Access Compliance Report

Public Rights-of-Way (Curb Ramps)

Intersection ID: 50763	Main Street: QUIET_CREEK_CR	Cross Street: SCOTT_CREEK_DR	Location: SE
ADA ID: 6909814A4098	Ramp Type: Perp	Initial Pass/Fail: Fail	Overall Compliance: No
Severity Score: 13.75			
Codes/Mitigation Info/Possible Solution		Field Measurements/Component Compliance

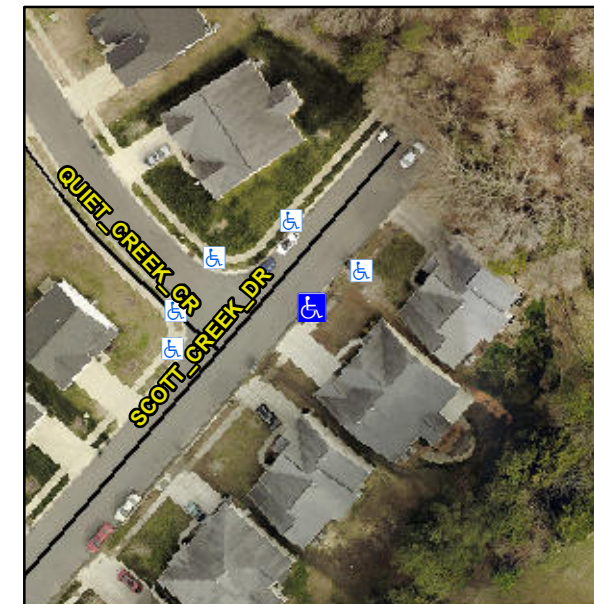
Not Found, R304.2.2, R304.5.3

Compliance	Description	Data	Compliance	Description	Data
N/A	Ramp Length (in)	47.5	No	Ramp Slope (%)	9.6
Yes	Ramp Width (in)	48.0	No	Ramp XSlope (%)	2.1
N/A	Flare Type LT	N/A	N/A	Flare Type RT	N/A
N/A	Flare Slope LT (%)	N/A	N/A	Flare Slope RT (%)	N/A
N/A	Flare Traversable LT?	N/A	N/A	Flare Traversable RT?	N/A
N/A	Landing Length (in)	N/A	N/A	DWS Provided?	N/A
N/A	Landing Width (in)	N/A	N/A	DWS Contrast?	N/A
N/A	Landing Slope (%)	N/A	N/A	DWS Length (in)	N/A
N/A	Landing X Slope (%)	N/A	N/A	DWS Full Width?	N/A
N/A	Landing Curb? (Y/N)	N/A	N/A	DWS Offset (in)	N/A
N/A	Shared Landing?	N/A			
N/A	Gutter Ponding?	N/A	N/A	Gutter Slope (%)	N/A
N/A	Gutter Lip Ht (in)	N/A	N/A	Gutter X Slope (%)	N/A
N/A	Painted X Walk1?	No	N/A	Painted X Walk2?	N/A
	X Walk 1 Direction	To NW		X Walk 2 Direction	N/A
N/A	X Walk 1 Width (in)	N/A	N/A	X Walk 2 Width (in)	N/A
	X Walk 1 Slope (%)	1.3		X Walk 2 Slope (%)	N/A
	X Walk 1 X Slope (%)	1.8		X Walk 2 X Slope (%)	N/A

Remove & Replace Entire Ramp.
